DATE:	MAY 2004	SCALE:	1"=20'(H) 1"=6"(V)	JOB NO.:	320-02
DRAWN:	G&A	DESIGN:	AKC	REVIEWED:	BRG
ARAPAHO ROAD PHASE III				DWG: 320STMP17	
PLAN & PROFILE					
STORM SEWER 'C' STA. 5+00 TO END					
TOWN OF ADDISON					
g&a Grantham & Associates, Inc.				SHT. SW-18	
1919 S. SHILOH ROAD, SUITE 310, L.B. 8 GARLAND, TEXAS 75042				(972) 864-2333 (TEL) (972) 864-2334 (FAX)

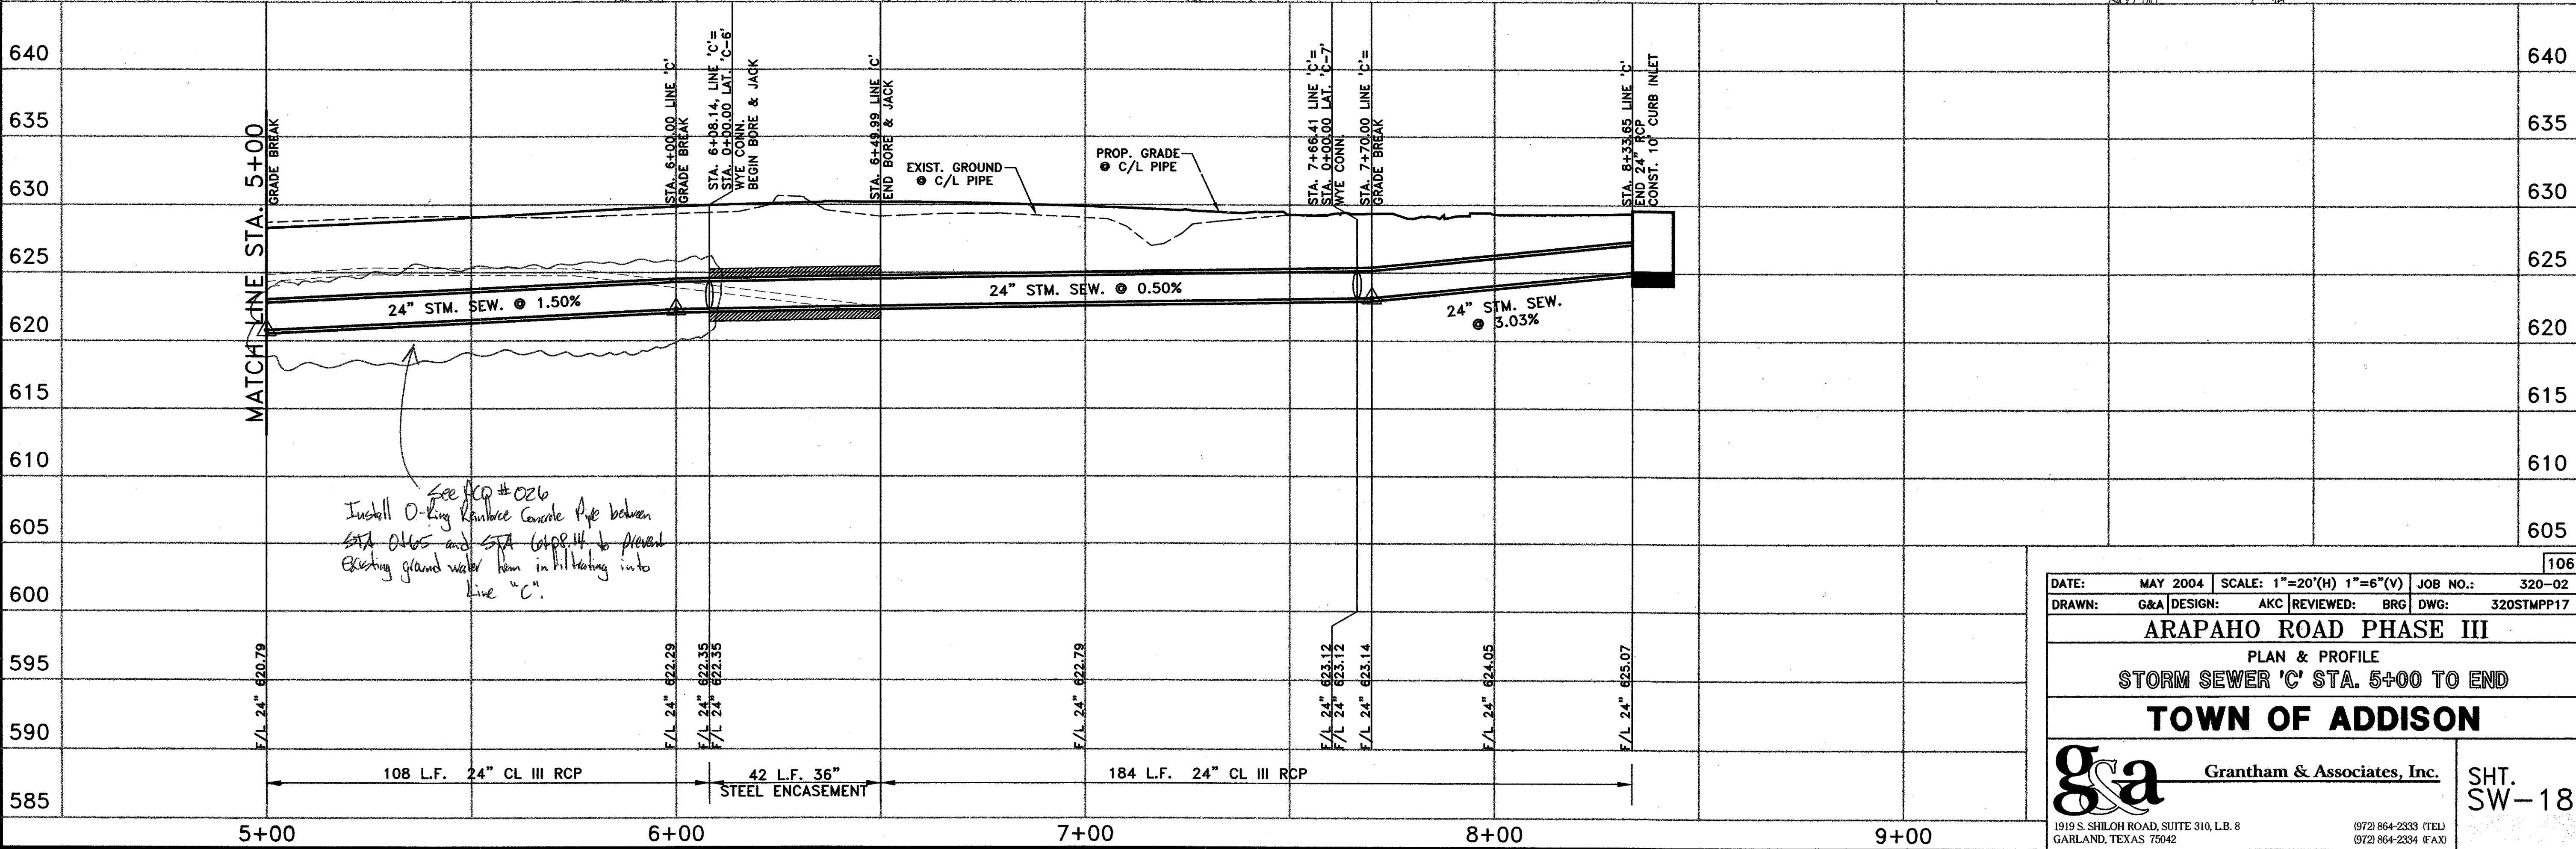
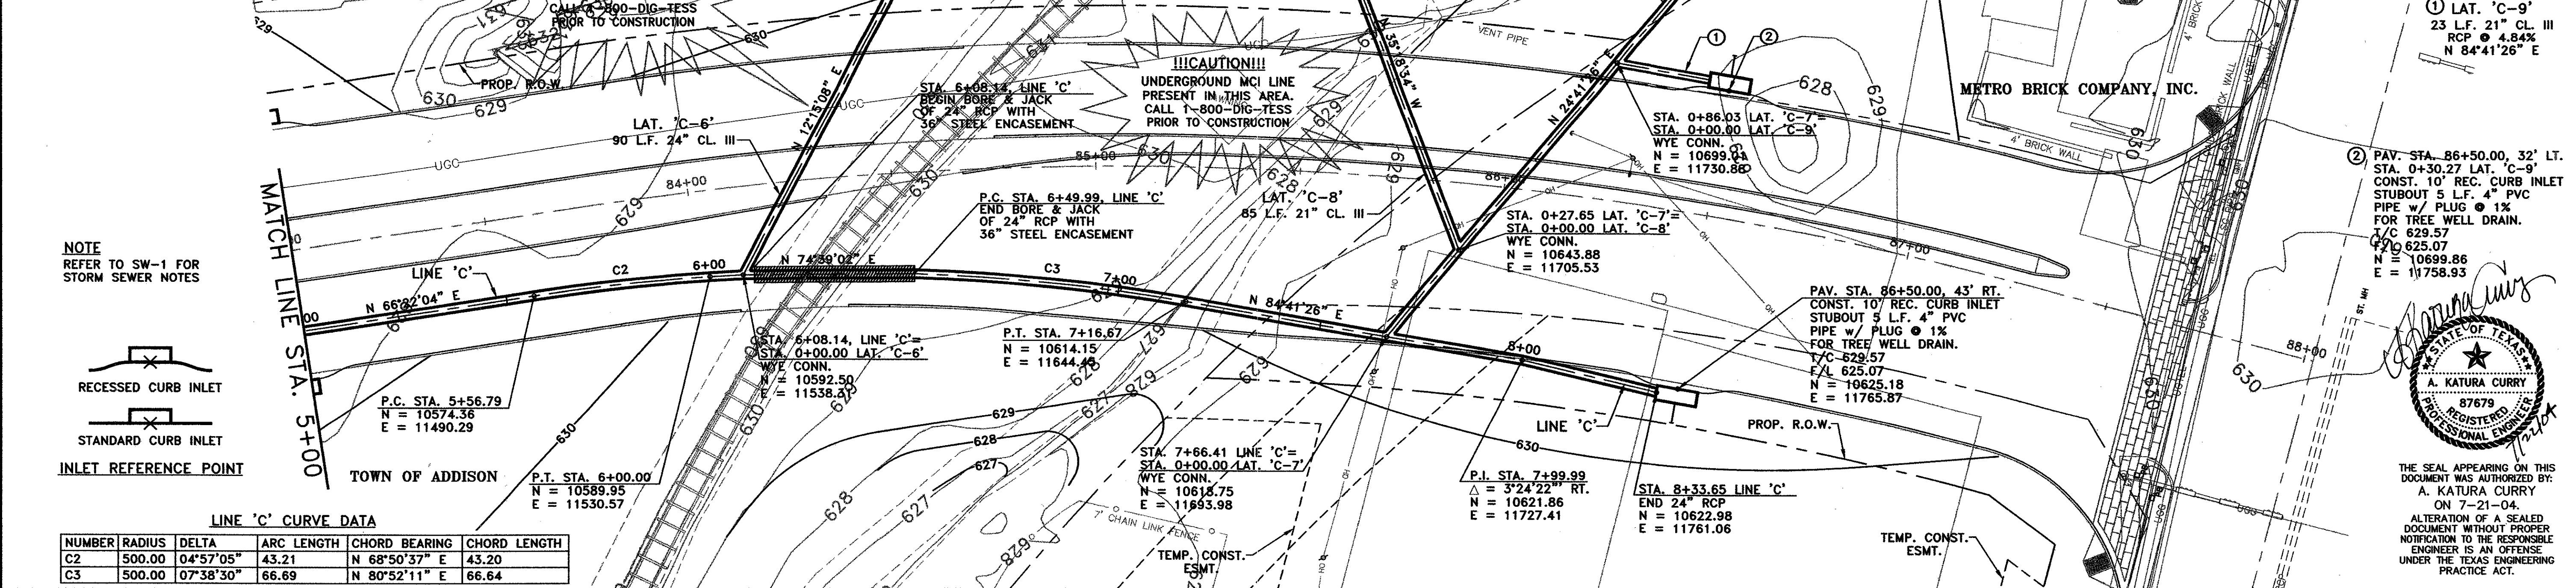
See ICP #026
Install O-Ring Rubber Conduit Pipe between
STA. 6+08 and STA. 6+49.99 to prevent
existing ground water from infiltrating into
Line "C".
